HARNESS 10021161-13-H2

Monterey Bay Aquarium Research Institute

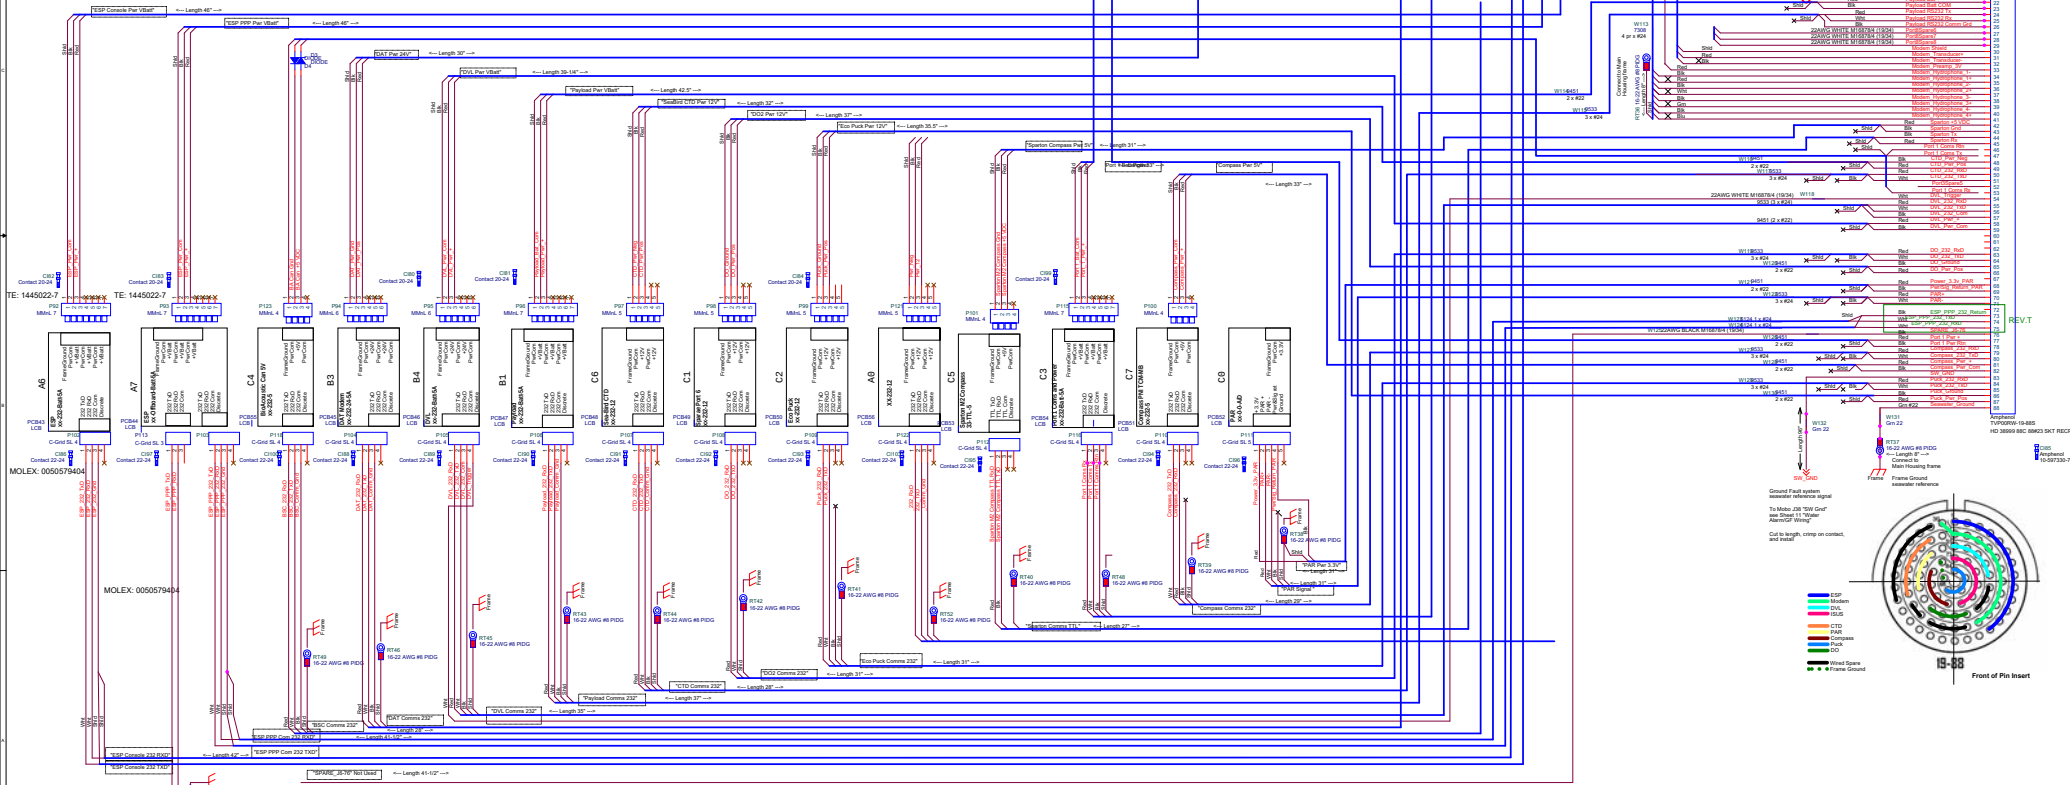
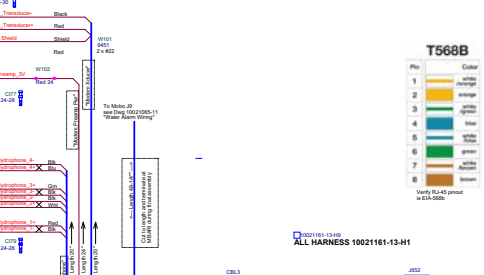
- T000:
- update connectors
 - cable length
 - LC can be 12V very small current

- T000:
- update connectors
 - check rx/tx on connector
 - what LC voltage/current?
